Local Transport Plan Objectives

Welcome to the Local Transport Plan 4 consultation survey. We've identified these objectives and we'd like your views on their priority.

Figure 1 AM Peak Modal Share presented by Herefordshire Council as evidence supporting the construction of the Hereford Relief Road

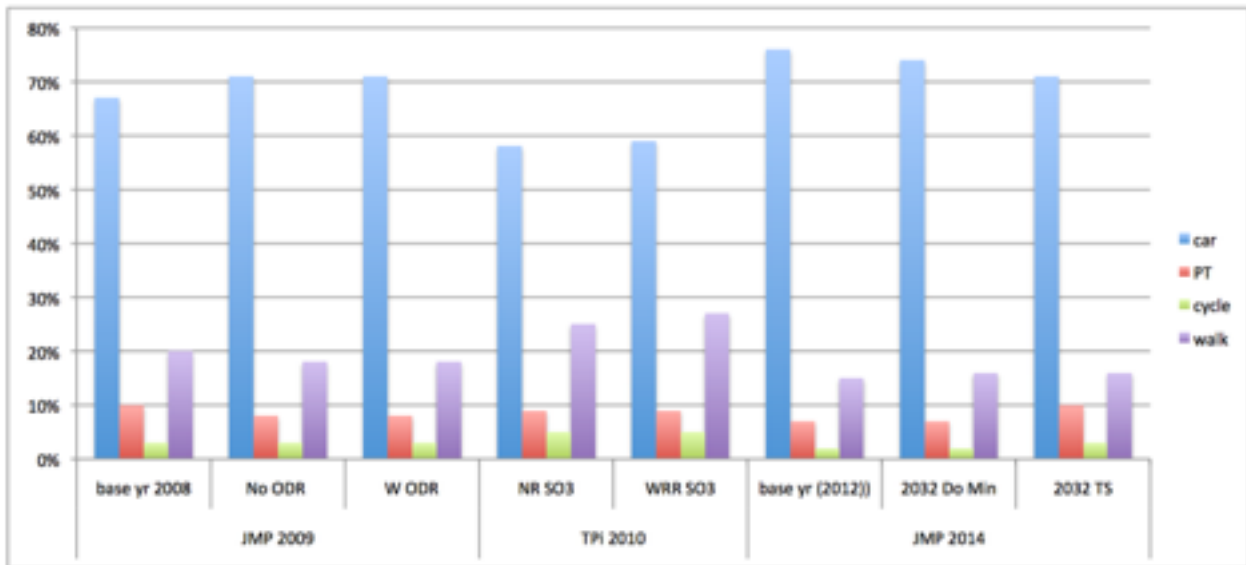
The conclusions rely on the Council's account of the outcomes of its policies and schemes, without reference to the evidence produced by the Council, ostensibly justifying its strategy. Notwithstanding very many general statements concerning the importance of active travel and the extent to which it will be supported by road building, all of the modelling evidence produced by the Council since 2008 shows that cycling will increase by very little. See Figure 1 below.

And even that negligible increase will only be achieved at the end of the period covered by LTP4, according to the consultation draft.

Cyclists in Hereford will be disadvantaged by all of the road schemes which pretend to be required in order to promote cycling, but will have very little effect according to the Council's own evidence (see Figure 1 above). Their main impact will be to divert investment from active modes and delay meaningful implementation.
